scope related to
'Planning application to vary a Condition
of Parent Application'

Drawing No: PL-300

Rev'n: B

proposed elevation

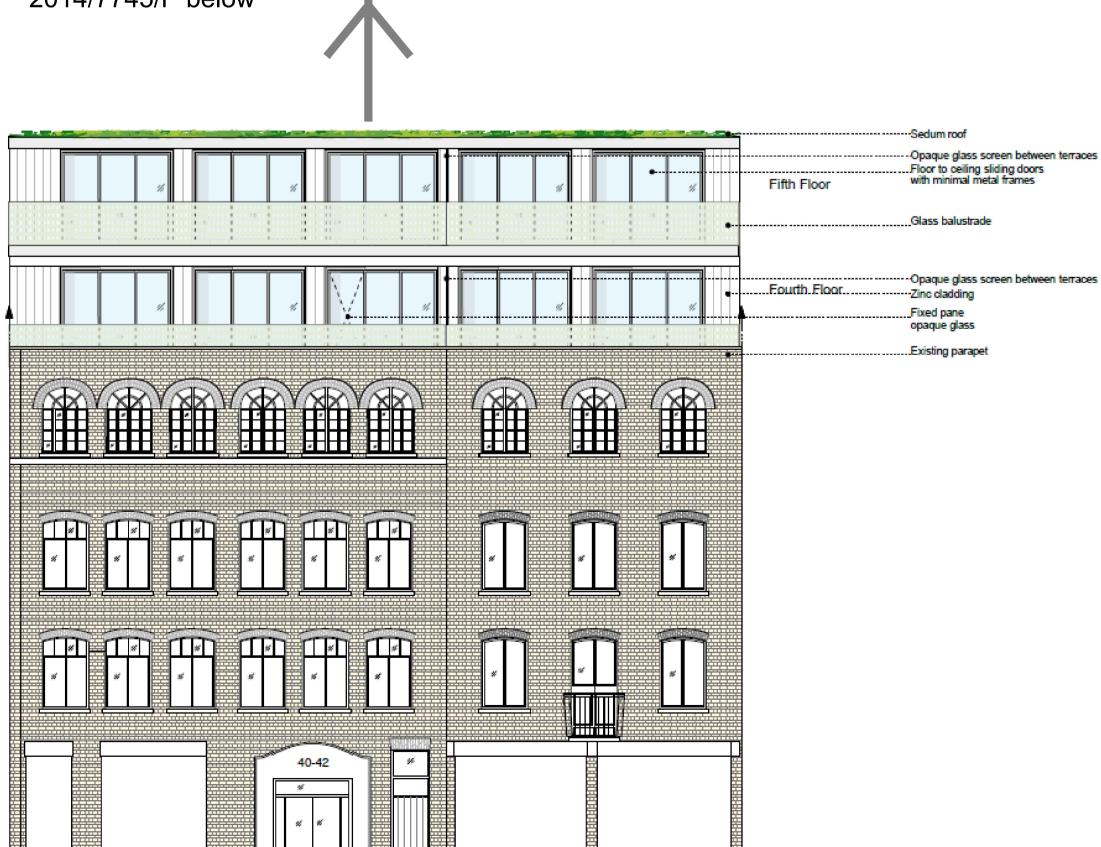
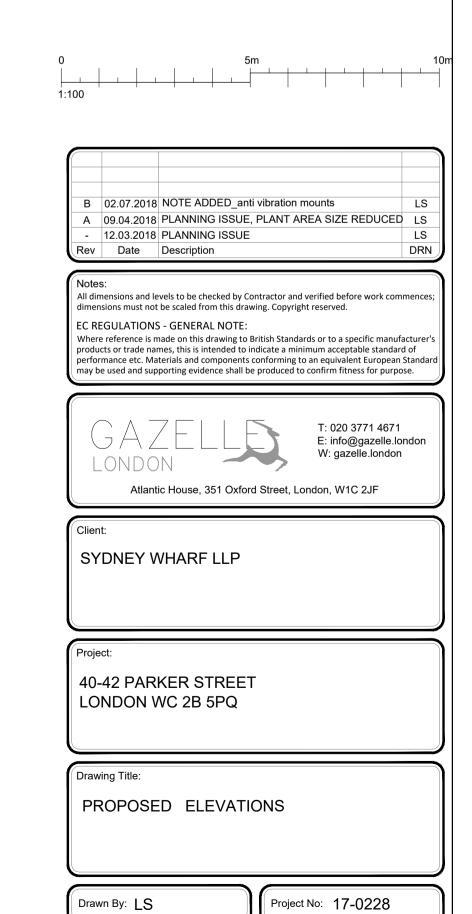
- plant room enlarged by 4.5sqm, enclosure cladding RAL 7021
- roof mounted plant (condensing units) location rationalised within an acoustic enclosure
- proposed elevation within the previously approved two storey scheme ref
 2014/7745/P below

NOTES
'provide anti vibration mounts
to roof mounted plants'
